RFQ NUMBER  
 DEP14998

LINE	QUANTITY	UOP	CAT. NO.	ITEM NUMBER	UNIT PRICE	AMOUNT
***** ADDENDUM NO. 1 *****						
ADDENDUM ISSUED FOR THE BUFFALO COAL CO. PROJECT IN GRANT CO., TO DISTRIBUTE THE PRE-BID SIGN-IN SHEETS, THE REVISED SITE DRAWING, REVISED PAGE ONE OF THE BID SCHEDULE, AND THE Q/A RESULTING FROM THE MANDATORY ON-SITE PRE-BID MEETING OF 06/17/10.						
BID OPENING DATE & TIME ARE EXTENDED FROM 07/15/10 TO 07/22/10 AT 1:30 PM.						
***** NO OTHER CHANGES *****						
0001	1	JB		962-73		
RECLAMATION: RESTORATION OF LAND						
***** THIS IS THE END OF RFQ DEP14998 ***** TOTAL: _____

**Addendum #1 - Questions During Pre-Bid Conference  
For DEP 14998  
Buffalo Coal Company, Inc.  
Permit # U-2010-94**

OFFICE OF SPECIAL RECLAMATION	
RECLAIMED PROJECT SITE	
SCALE: NTS	DRAWN BY: SN
DATE: 02/18/10	PROJECT NO.:

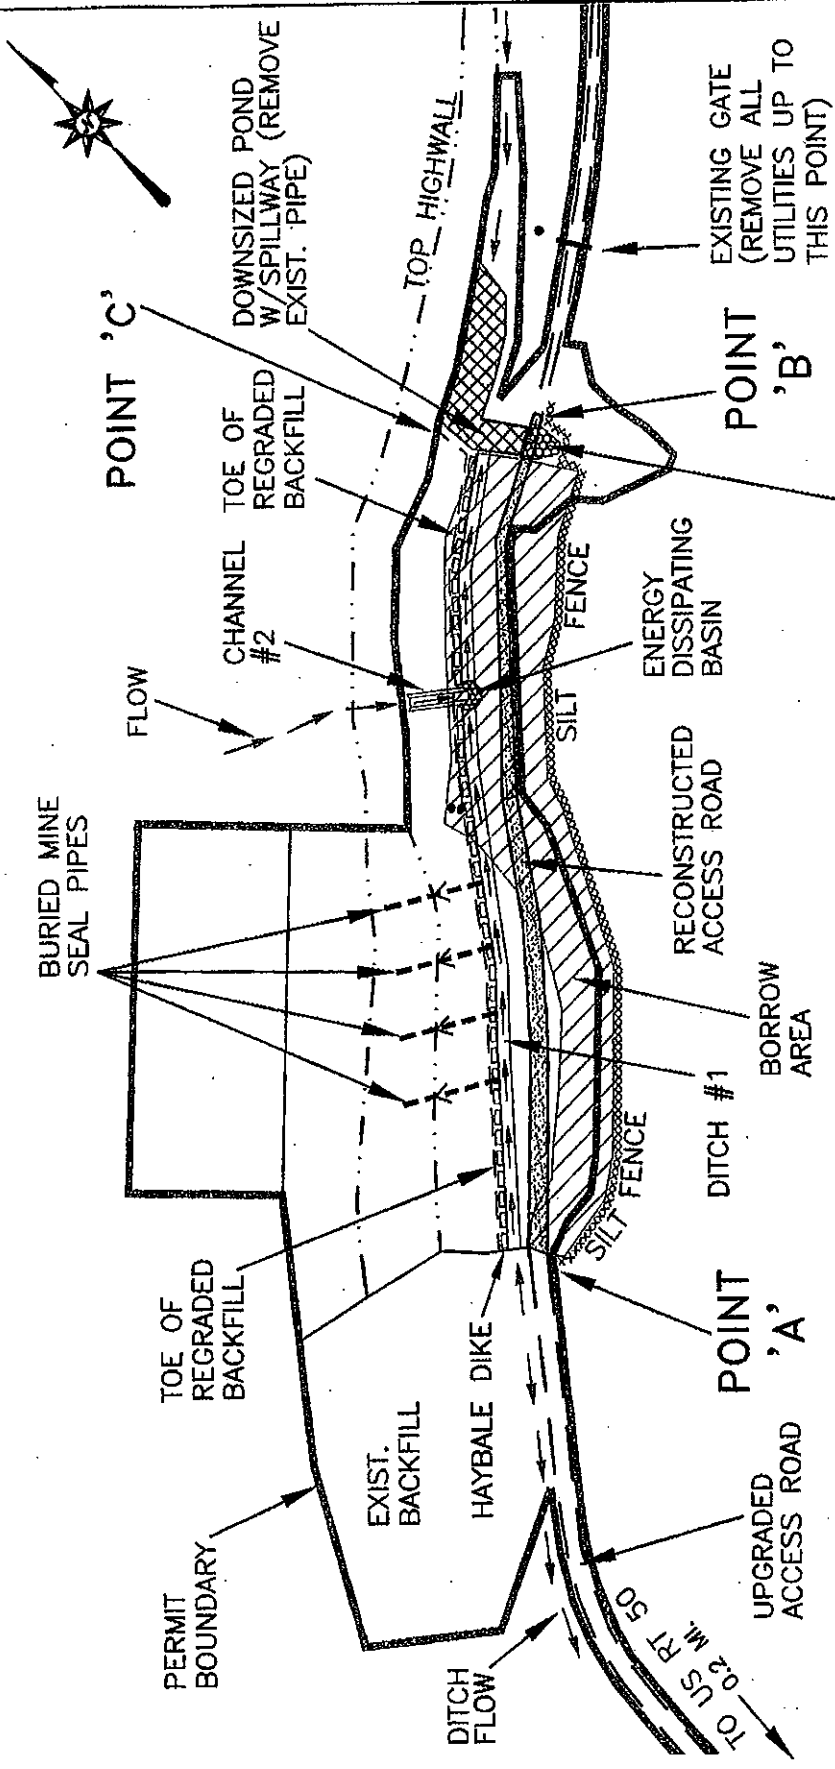
- **Delete item 7.0 "Soil Material" from the bid schedule. This item will NOT be used.**
  - **The "Reclaimed Project Site" drawing was missing from the Purchasing Division bid packet. This drawing was handed out at the PBC.**

- 9.) Q. How far up there are you going for material (toward the south end or Point A from drawing), you are showing that flow going that way (toward the main road)?

A. We will start the backfilling at Point A from drawing, where the existing backfilled section stops.
- 10.) Q. If you are on pavement here, do we have to chip material out to get positive flow out of the mine pipes?
